WILLIAMSON COUNTY, TEXAS CHANGE ORDER NUMBER: 1

Southeast Loop Phase 1 Road Improvements Williamson County Project No. T3346

Change Order No. 1

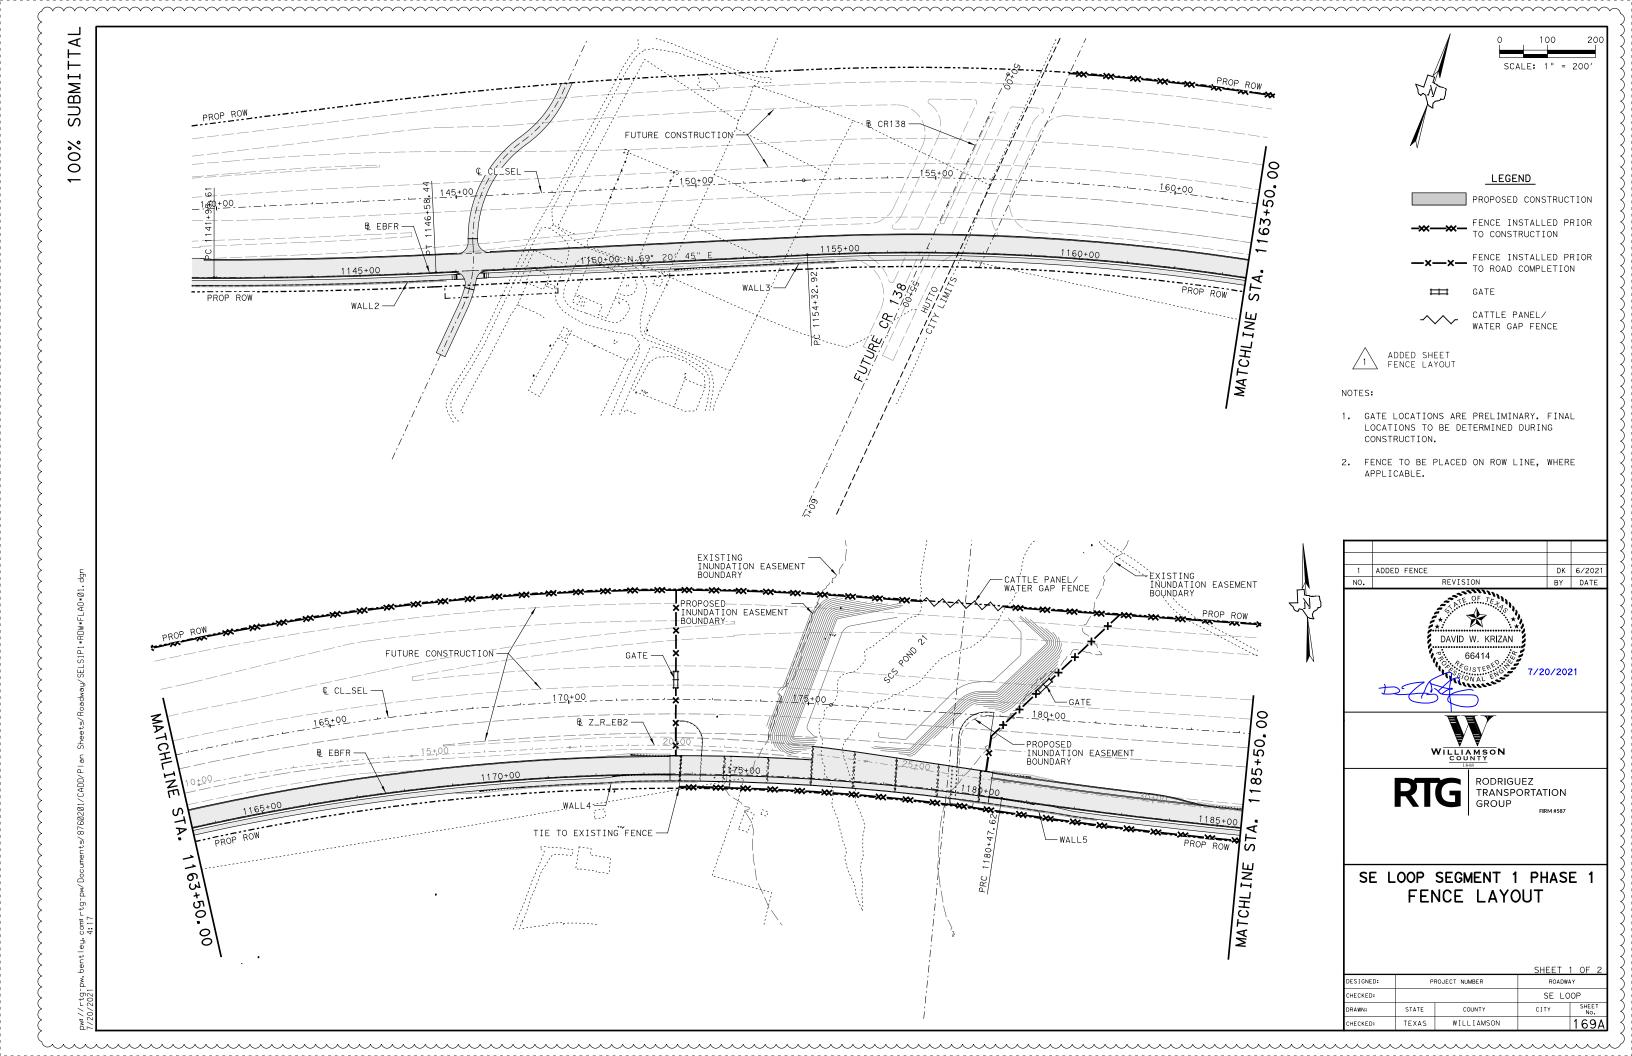
This Change Order adds the installation of barbed wire fence and gates along the north and south sides of the right-of-way (ROW) through the Wolfe property.

The property owner was not compensated for the fencing placed along the ROW during the negotiations for the property with Williamson County. The installation of the fence is being added to the roadway construction portion of the project. The wire fencing will match the existing fencing on of the property. The Wolfe parcel is a large parcel on the east end of the project and the work in this area is in Phase 1 of the construction sequence. Time charges began on July 19th and the Contractor will not be able to work in that area until the fence is installed due the cattle on the property.
